U.S. NUCLEAR REGULATORY COMMISSION  
REGION I

Report No. 50-247/84-13

Facility Name: Indian Point Nuclear Generating Station, Unit 2

Inspection Summary: Inspection on June 12-15, and July 5-6, 1984 (Report No. 50-247/84-13)

46' Elevation of Primary Containment  
(Inside Crane Wall)

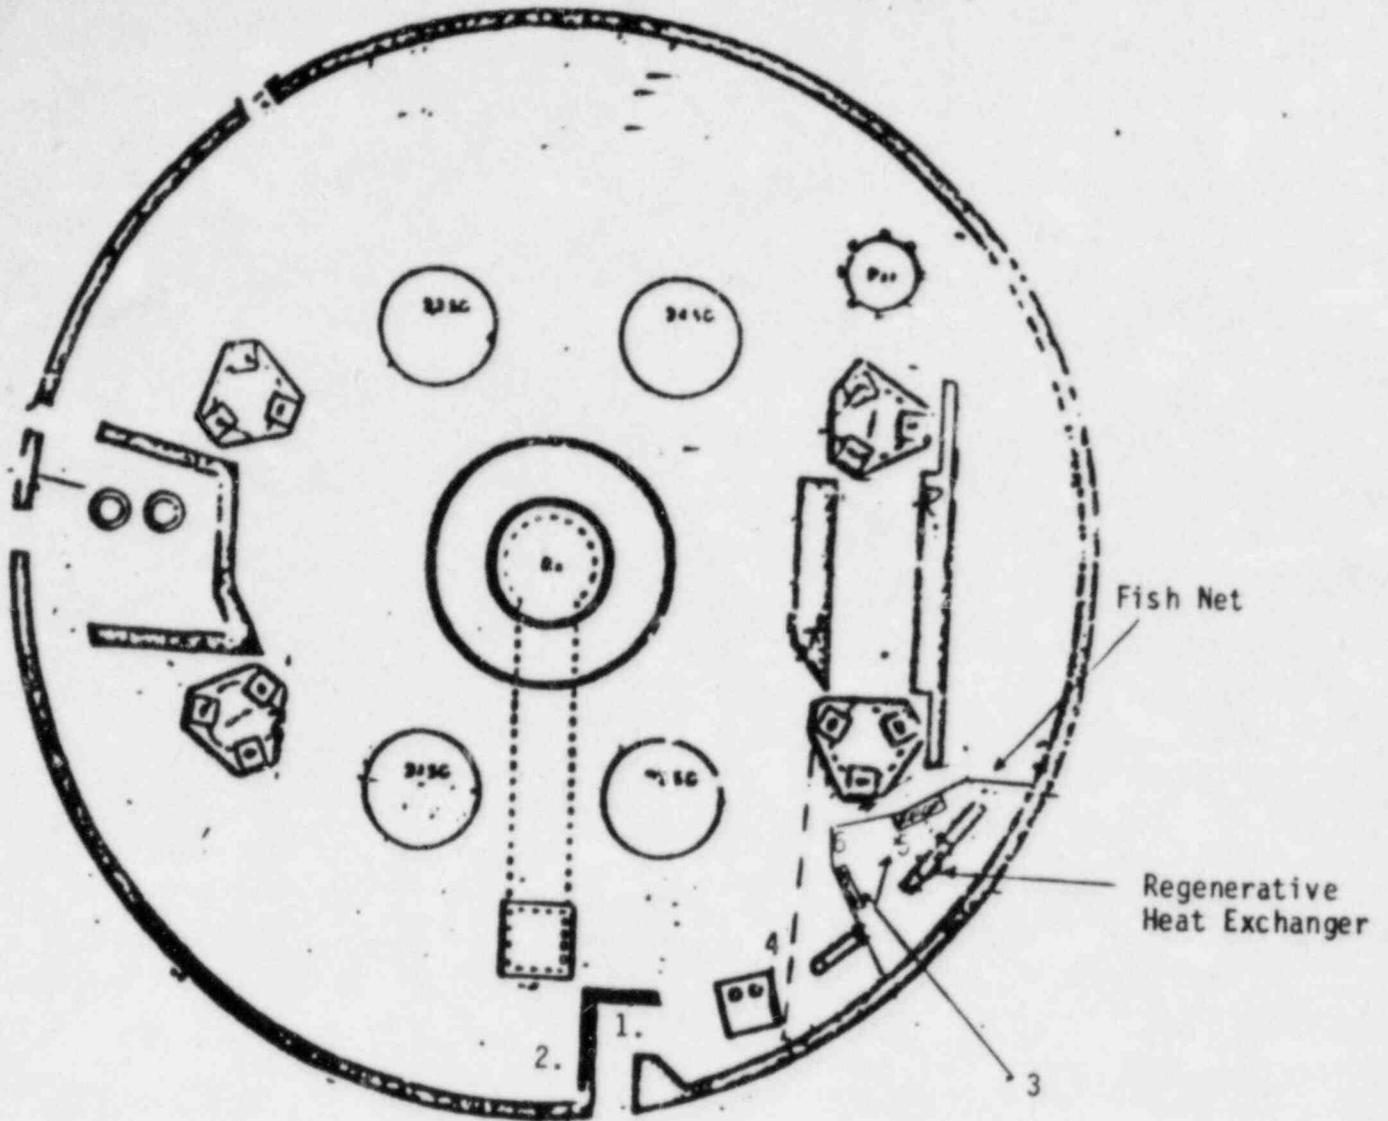
On June 19, 1984 at about 3:00 p.m. three Contractor workers were suited up at the 95 foot elevation access point in preparation for work on the number 21 steam generator. The suiting up included placement of multiple dosimeters on the workers. The workers were then led to the 46 foot elevation of the primary containment south access control point by a licensee Radiation Protection Supervisor. Believing that the workers were to be needed at the work area shortly, the Radiation Protection Supervisor directed a Junior Radiation Protection Technician at the Control Point to send the three workers inside the crane wall to wait in a low dose rate area until they were called. The workers donned their head-sets and air-supplied hoods and were directed to wait at the labyrinth area (See Figure 1).

The workers entered the temporary shield cubicle of the Regenerative Heat Exchanger (see Figure 1) and proceeded to wait in the area until called. Unbeknown to the workers, the area was a High Radiation Area with radiation dose rate between 2000 millirem/hour and 4000 millirem/hour. The

to work. Due to insufficient instructions to the workers, the workers entered and waited in a high radiation area next to the Regeneration Heat Exchanger. 10 CFR 19.12, "Instructions to Worker", require that workers be instructed in precautions and procedures to minimize exposure. This appears to be an apparent violation of 10 CFR 19.12, "Instruction to Workers" (50-247/84-13-08).

- On June 19, 1984 the entrances to the Regenerative Heat Exchanger Area, an area exhibiting general area radiation dose rates between 2000 millirem/hour and 4,000 millirem/hour was not locked or otherwise controlled in any manner to preclude unauthorized entrance thereto. Technical Specification 6.12.1.b requires, in part, that the access to high radiation areas greater than 1000 millirem/hour be controlled. This appears to be an apparent violation of Technical Specification 6.12.1.b, "High Radiation Area" (50-247/84-13-09).
